September 3, 2024

Consideration of a proposed approximately 16,000 square foot supermarket building and site improvements, including parking and landscape areas. The 2.24 acre site is located at 4951 Biddle Road and is identified on the Jackson County Assessor's map as 37S 2W 01C, Tax Lot 802.

AGENDA ITEM: Site Plan and Architectural Review (SPAR-24004) application to construct an approximately 16,000 square foot building on approximately 2.24 acres in the C-5, Thoroughfare Commercial zoning district, for use as a Grocery Store - 37S 2W 01C, Tax Lot 802.

SHEET NAME:
SITEPLAN

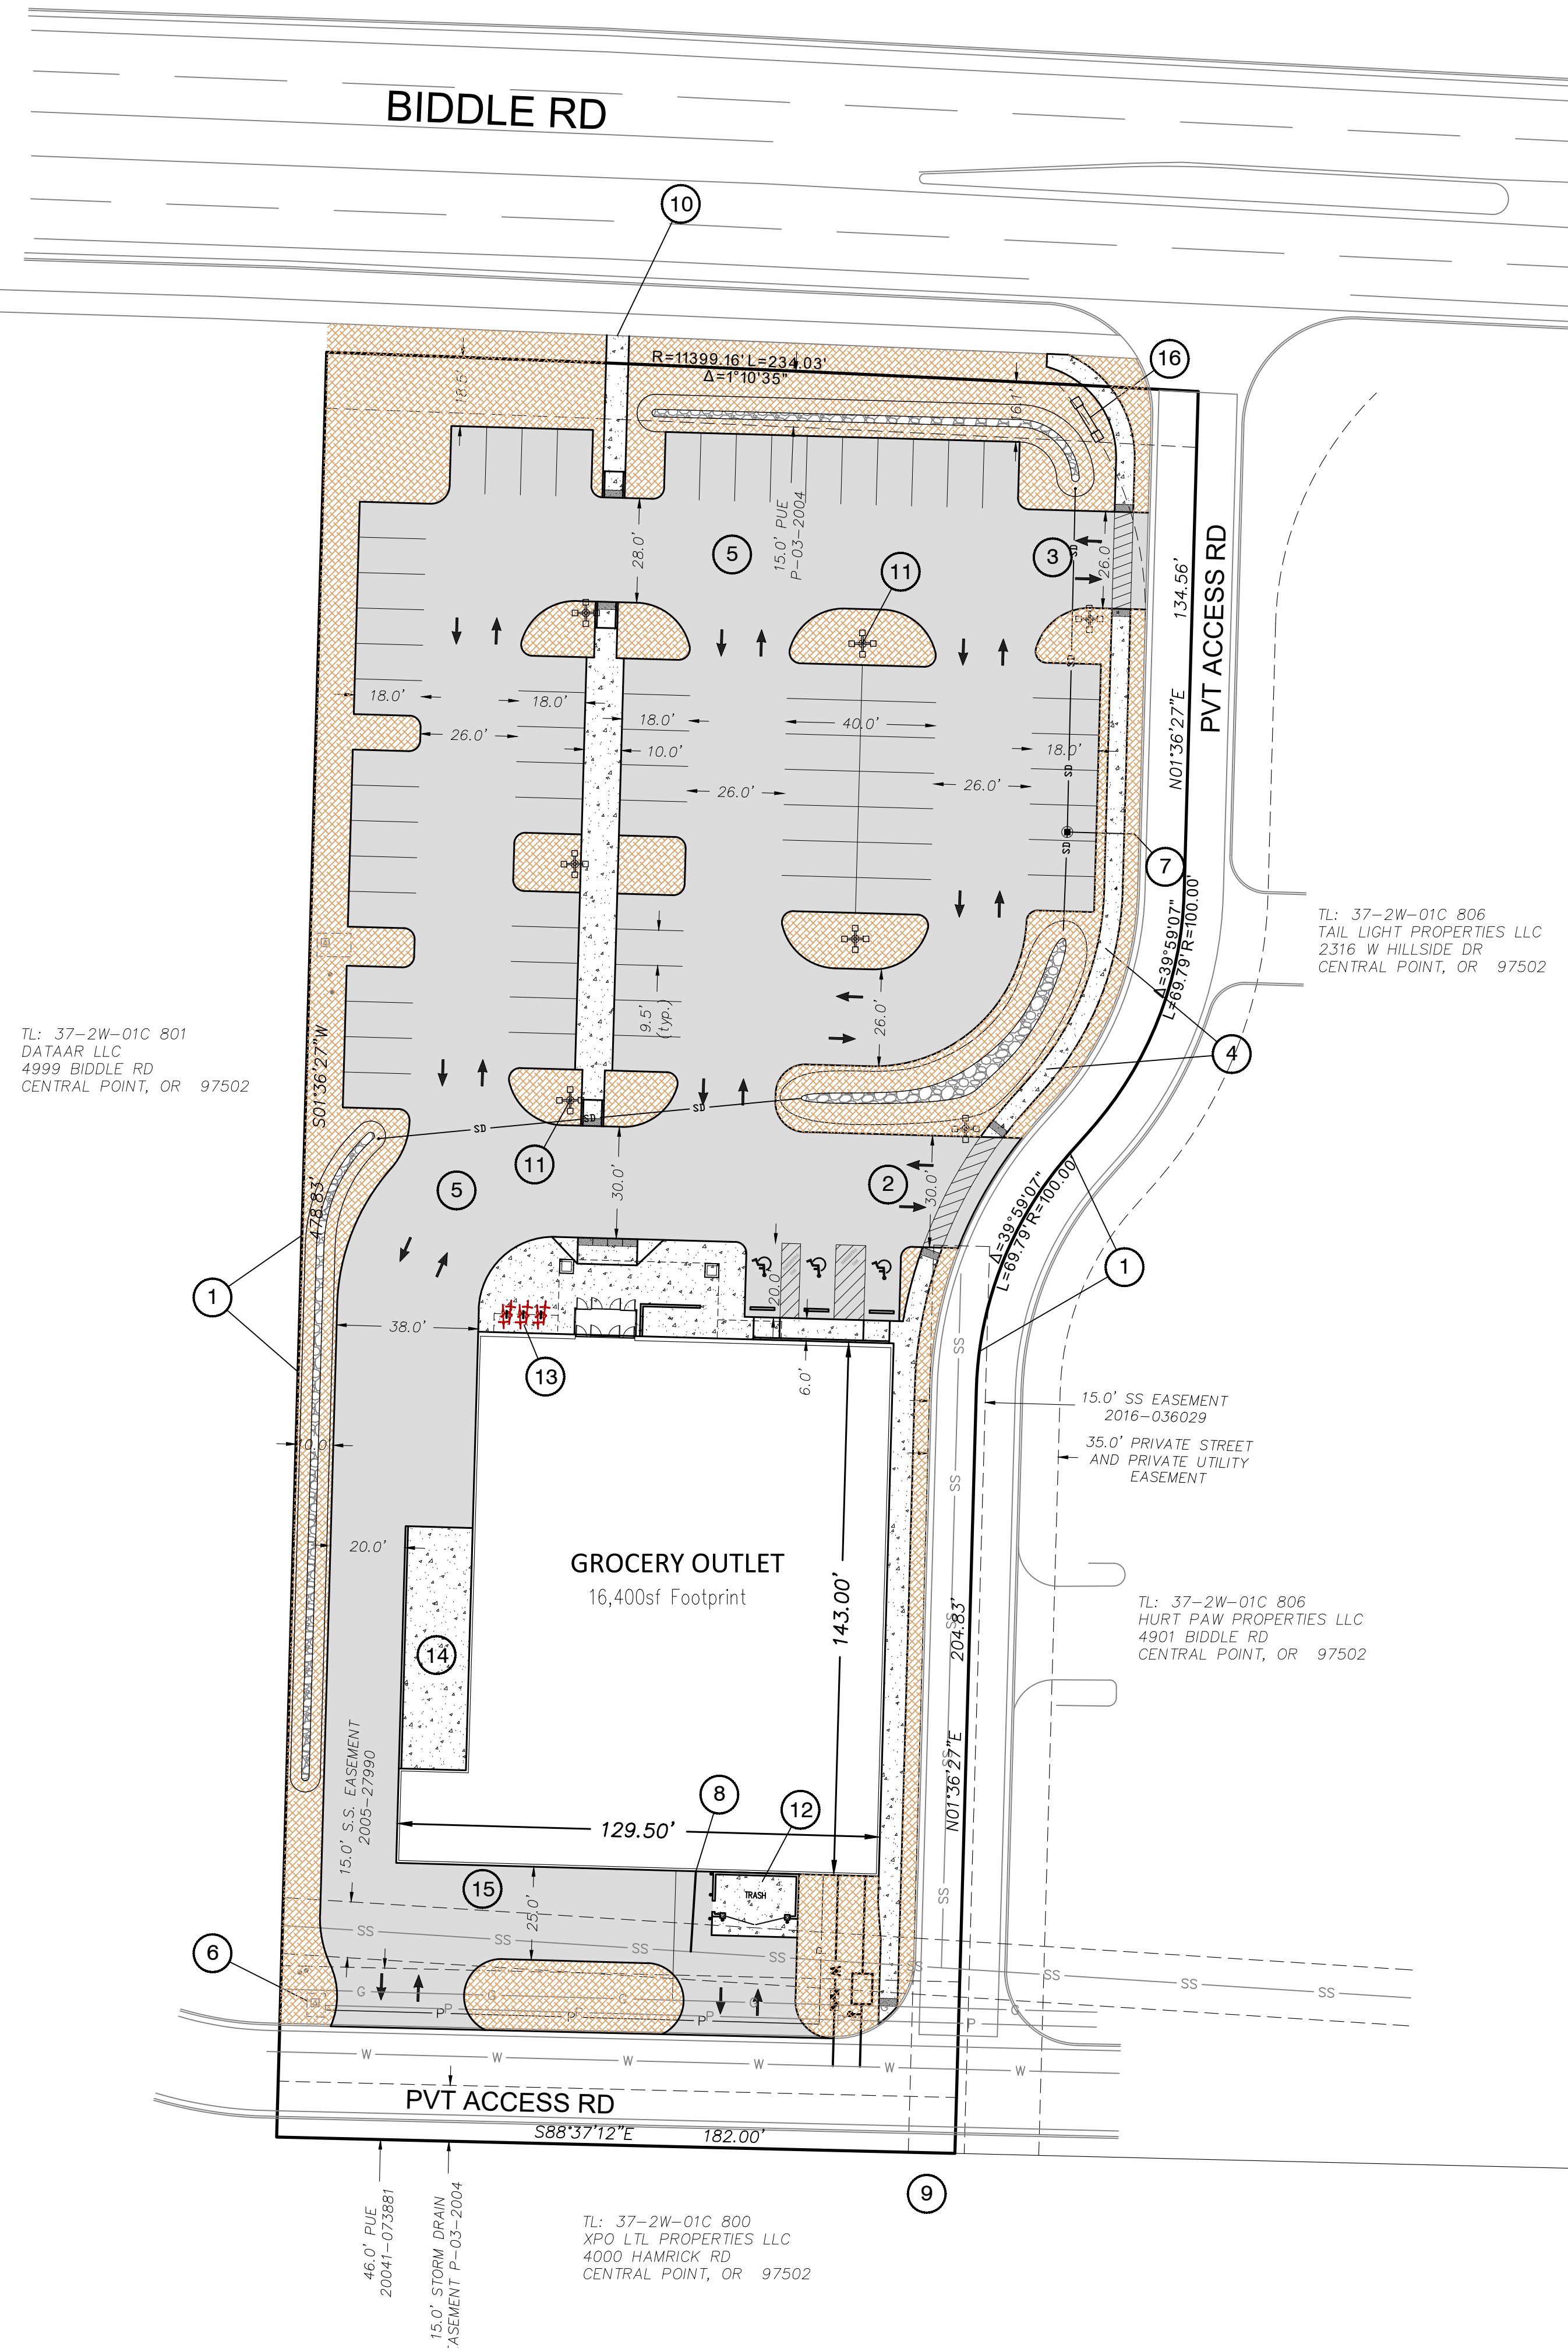
- e. Demonstrate compliance with Fire District No. 3 Staff Comments, including:
 - i. Submit a revised site plan that depicts the location of a new fire hydrant, if the location of the FDC on the proposed building is greater than 50-feet from an existing fire hydrant.

LANDSCAPE PLAN

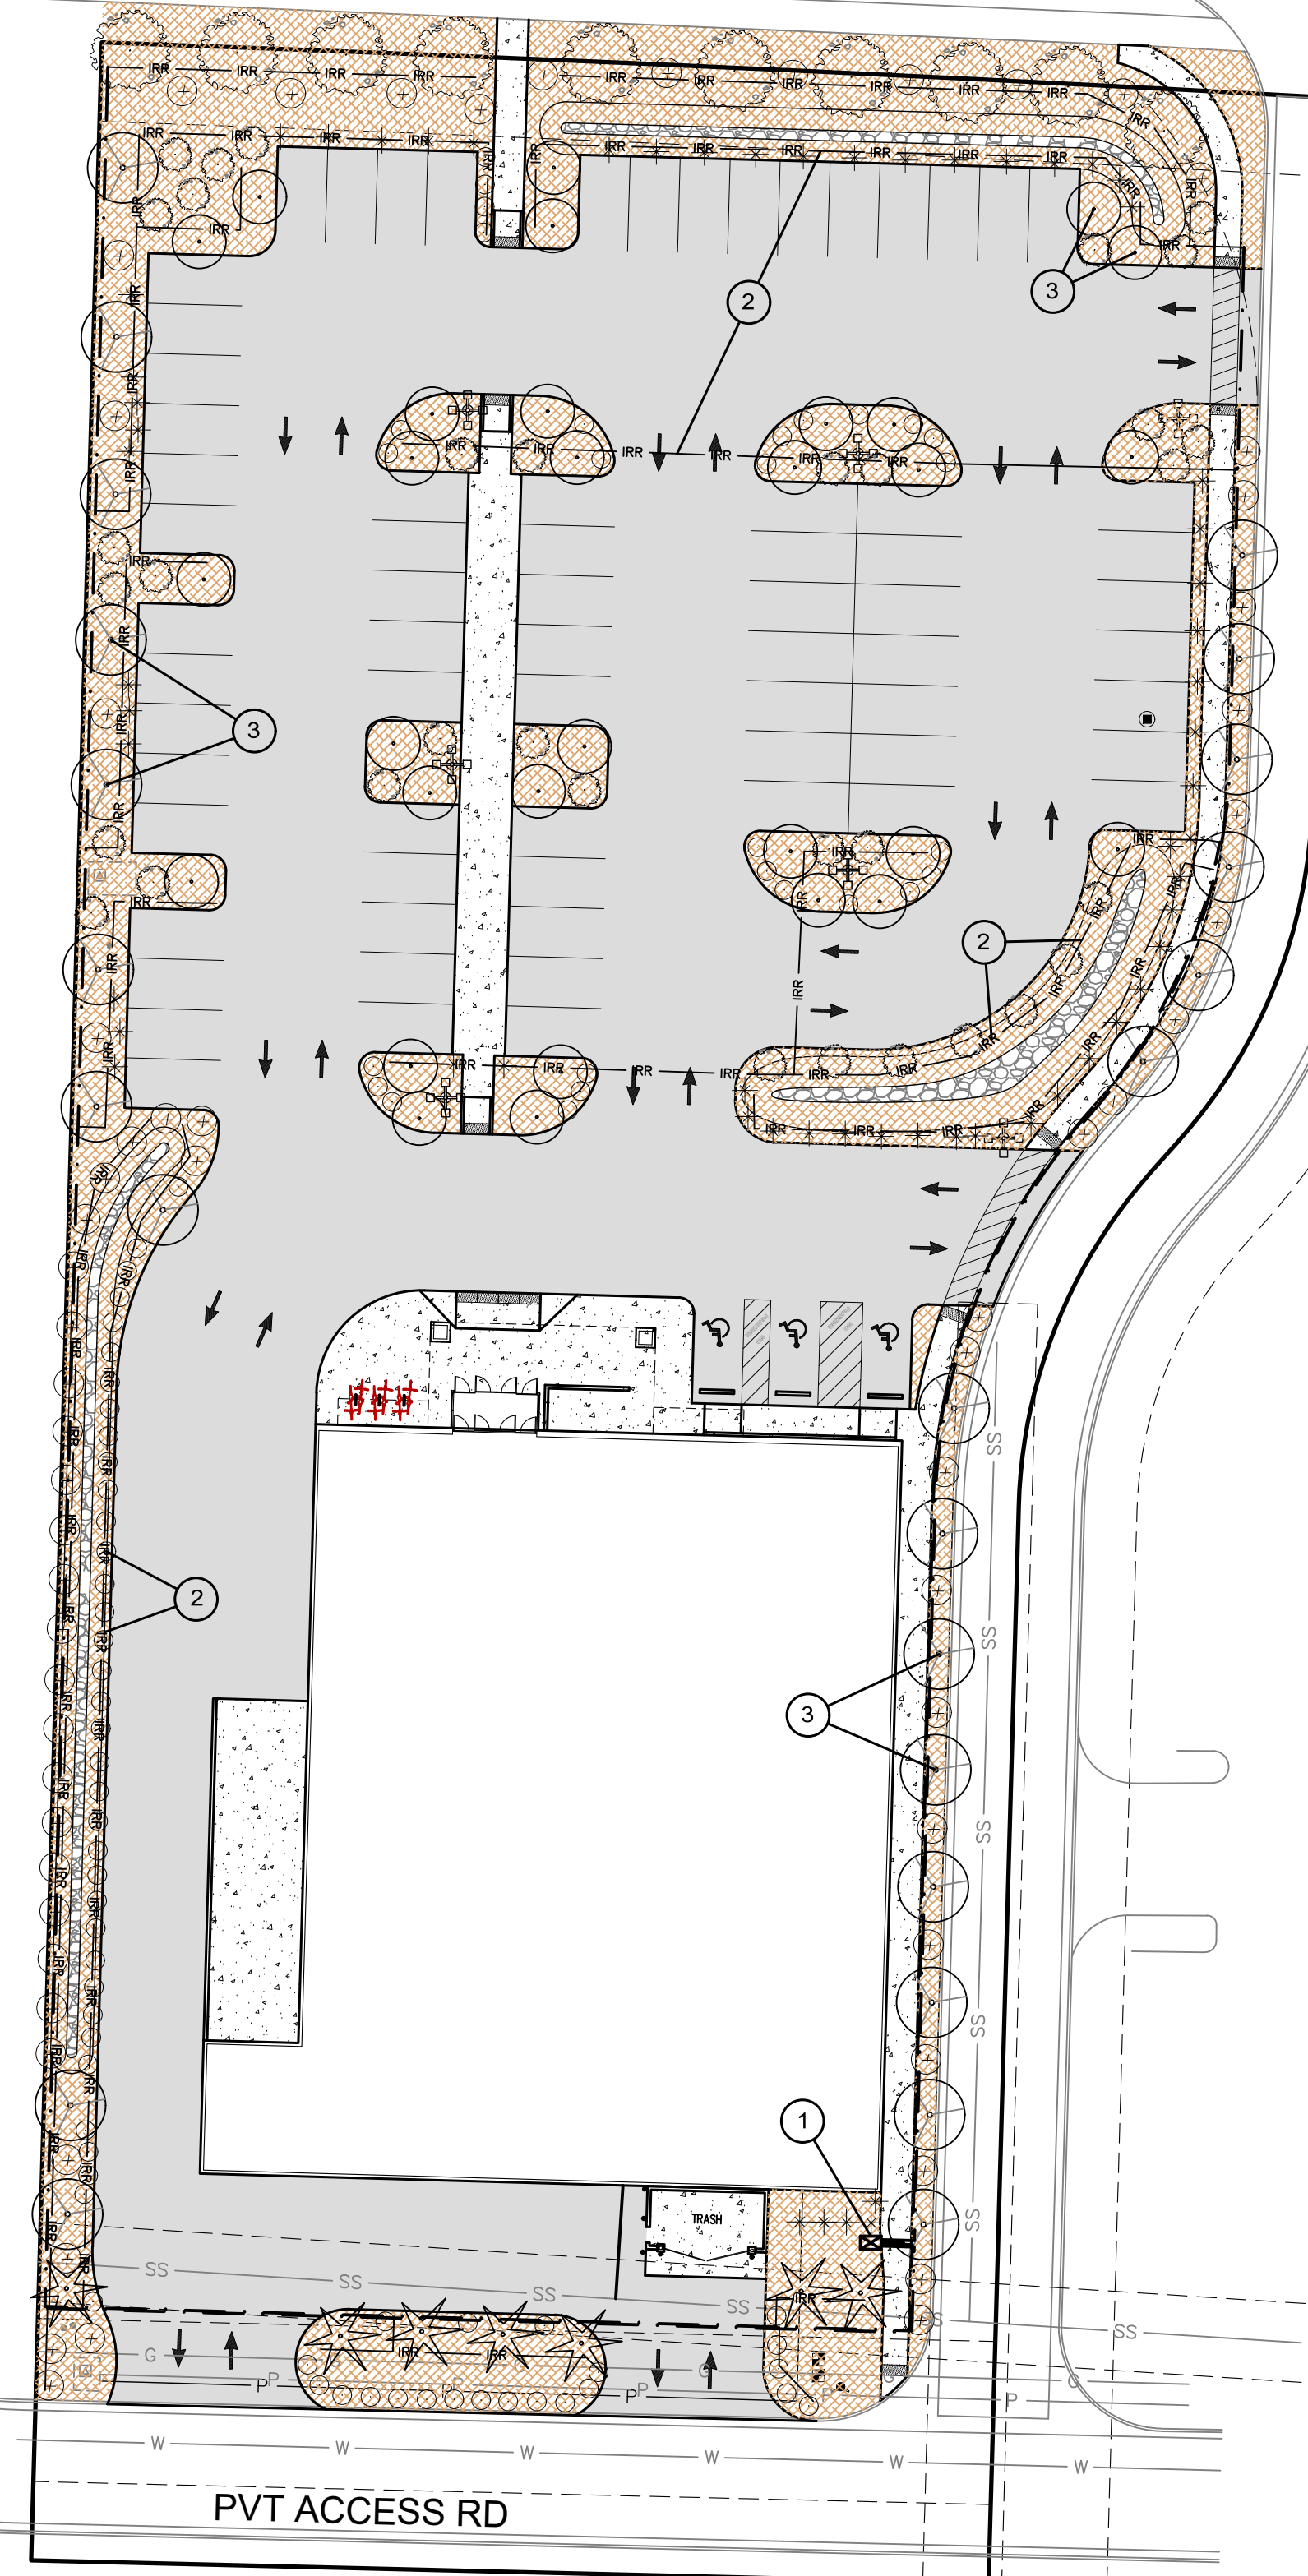
1. **Frontage Improvements/Landscaping.** Biddle Road is classified as an Urban Minor Arterial maintained by Jackson County. The right-of-way includes curb, gutter and sidewalk, with a landscape row between the curb and sidewalk. The Landscape Plan (Attachment “A-2”) does not include landscaping or irrigation in the landscape row. The landscape row must be landscaped with ground cover and provide irrigation to proposed landscaping.

Comment: Staff recommends Condition of Approval No. 1(a) requiring a revised landscape plan that provides ground cover and irrigation for the landscape row along Biddle Road.

1. Prior to building permit issuance for the supermarket/grocery store building, the applicant shall satisfy the following conditions of approval:
 - a. Submit revised landscape plan that depicts the landscape row along the Biddle Road with ground cover and irrigation;

- a. **Landscape Plan.** The applicant shall prepare a landscape and irrigation plan to install ground cover along the Biddle Road frontage.
- b. **Sidewalks.** A private sidewalk is required along the east and south sides of the private streets. Sidewalk widths shall match the existing sidewalk on the east side of the existing private street. ADA-compliant ramps are required at the intersection of the two private streets at the site's southeast corner. In addition, ADA-compliant ramps will be required at all access entrances.
